## T-052 SERVICE BULLETIN

### Installation of E23032283-1, -2, -3 Bearing Cage

<b>Engine Application(s):</b>	Allison 250-C20, C20R, B17, B17F
<b>Subject:</b>	Installation instructions for E23032283-1, -2, -3 Bearing Cages.
<b>Compliance:</b>	Any time the subject part numbers are installed.
<b>Revisions:</b>	N/C Dated: 03/29/00 Initial Release. A Dated: 09/01/09 Updated EXTEX to TIMKEN. B Dated: 2/04/16 Updated Timken to EXTEX Engineered Products.

**Figure 1**

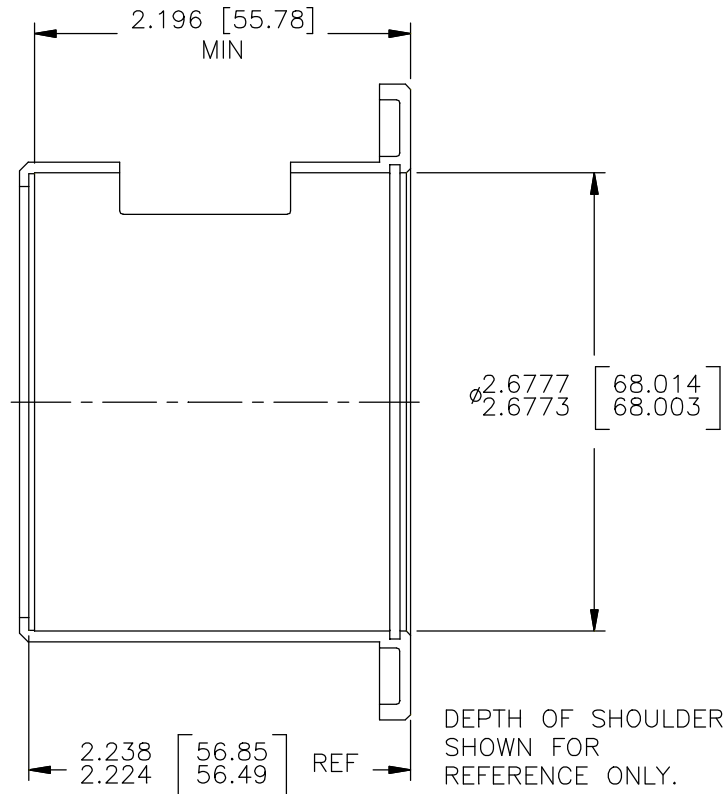
1. Comply with all OEM requirements pertaining to the gearbox cover assembly.
2. Select a new pinion bearing cage, P/N E23032283-1, -2 or -3 to provide a line-to-line to .001" tight fit in the bore of the cover. See Table 1 for OD dimensions of the cage.
3. Heat the area around the cage bore to 300°F (149 °C) maximum. Align the holes in the cage flange with the holes in the cover and press the cage into the cover until it is fully seated against the cover.
4. Machine the ID of the installed cage as shown in Figure 1. The depth of the shoulder is referenced for planning purposes only. Axis of machined ID must be square with splitline of cover assembly within .001 TIR and located within .002 of True Position. Coat the exposed (machined) surface of the cage

5. Inspect the machined areas for compliance to Figure 1.
6. Re-identify the reworked gearbox cover assembly per OEM requirements.
